CONTRACT CHANGE ORDER NO. _____
SHEET ____ OF ____

MARK	DATE	DESCRIPTIONS	BY	CH'D	CCO#
0	10/11/11	SUSPENDER PROTECTION @ PP 98	GB	JD	200S1

SAN FRANCISCO OAKLAND BAY BRIDGE
EAST SPAN SEISMIC SAFETY PROJECT
SELF-ANCHORED SUSPENSION BRIDGE
(SUPERSTRUCTURE & TOWER)

CABLE BAND DETAILS NO. 6

SUSPENDER PROTECTION AT PP 98 (See Note 1) (EB shown, WB similar)
1:20

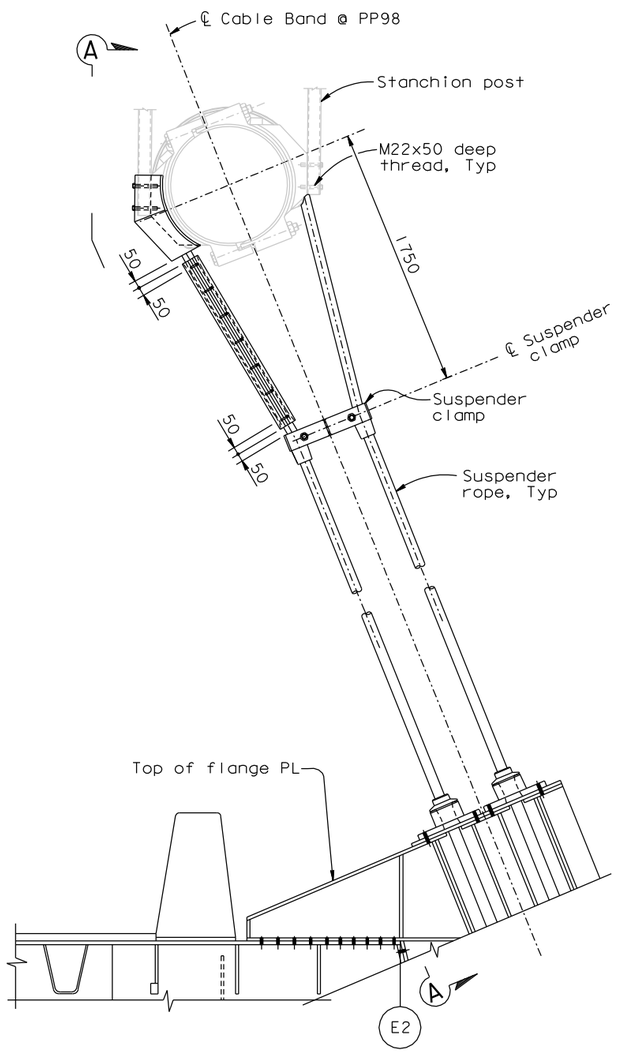
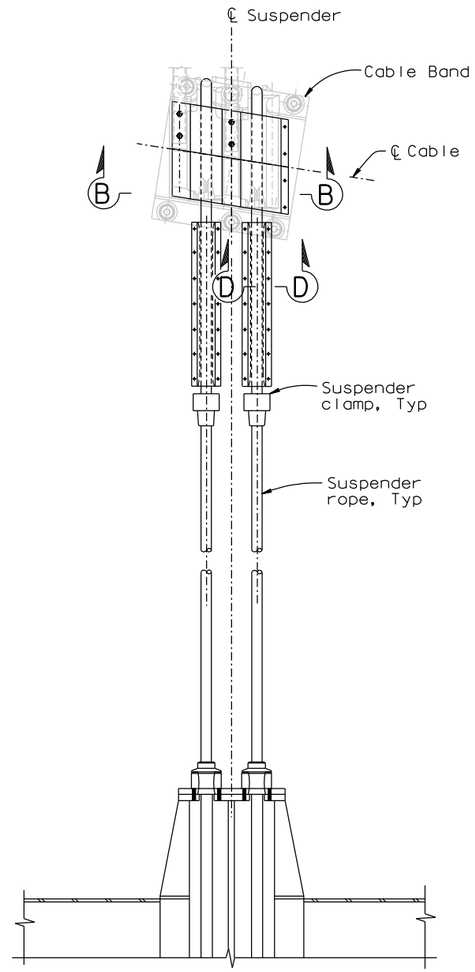
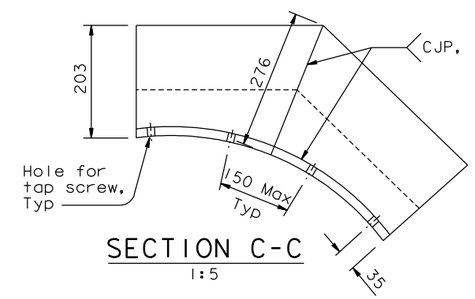
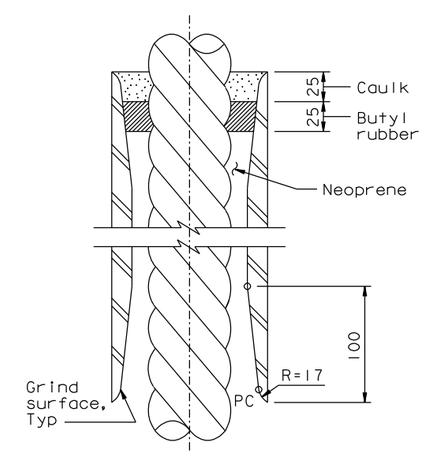
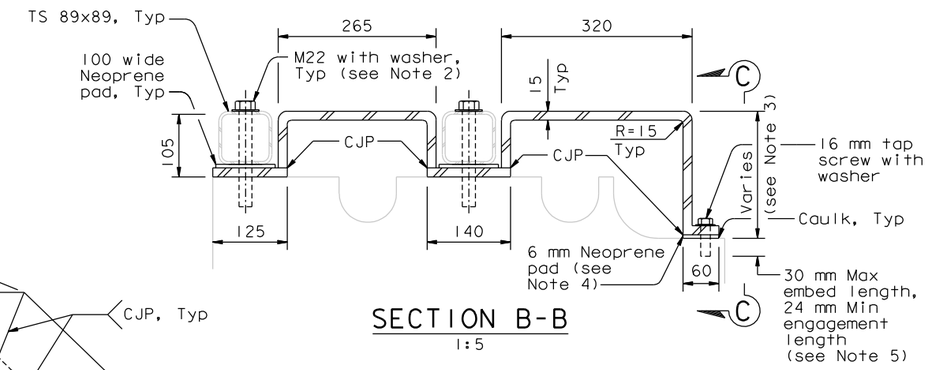
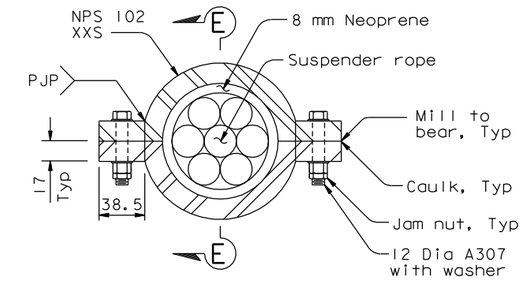
1. If the Department obtains a waiver to reduce the minimum clearance height between the roadway at the interior edge of the barrier and the Cable Band at PP 98, the Engineer shall direct the use of the suspender protection at PP 98.
2. M22 bolts shall be replaced with new longer M22 bolts.
3. Cable band shall be surveyed and cover plate shall be fabricated to match.
4. Neoprene pad shall be used to ensure tight fit between cable band and cover plate. Grind cable band as necessary.
5. Cable band shall be MT tested after drilling and tapping.
